# Technical Service Bulletin

## 19 A8 4.2 FSI - Coolant leak in Engine compartment

19 13 34 2028574/2 February 5, 2013. Supersedes Technical Service Bulletin Group 19 number 12-29 dated February 7, 2012 for reasons listed below.

Figure 1. Connector hose (7).

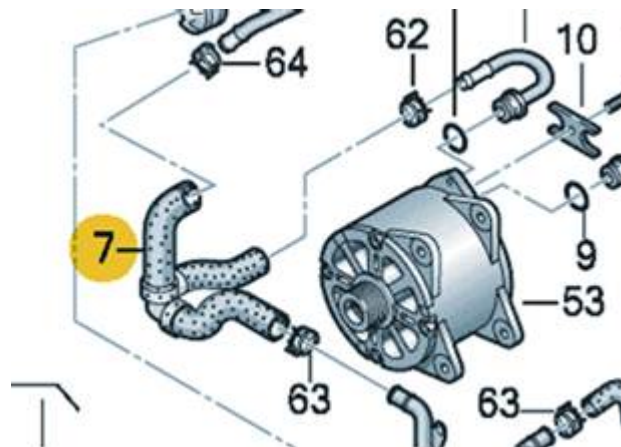
The possible cause is a leak on the tee connector hose located in the coolant pipe between alternator, coolant pipe, and oil cooler.

Pressurize cooling system. Check the tee connector hose (part number **079121448**) in the coolant circuit for leaks, and replace if necessary.
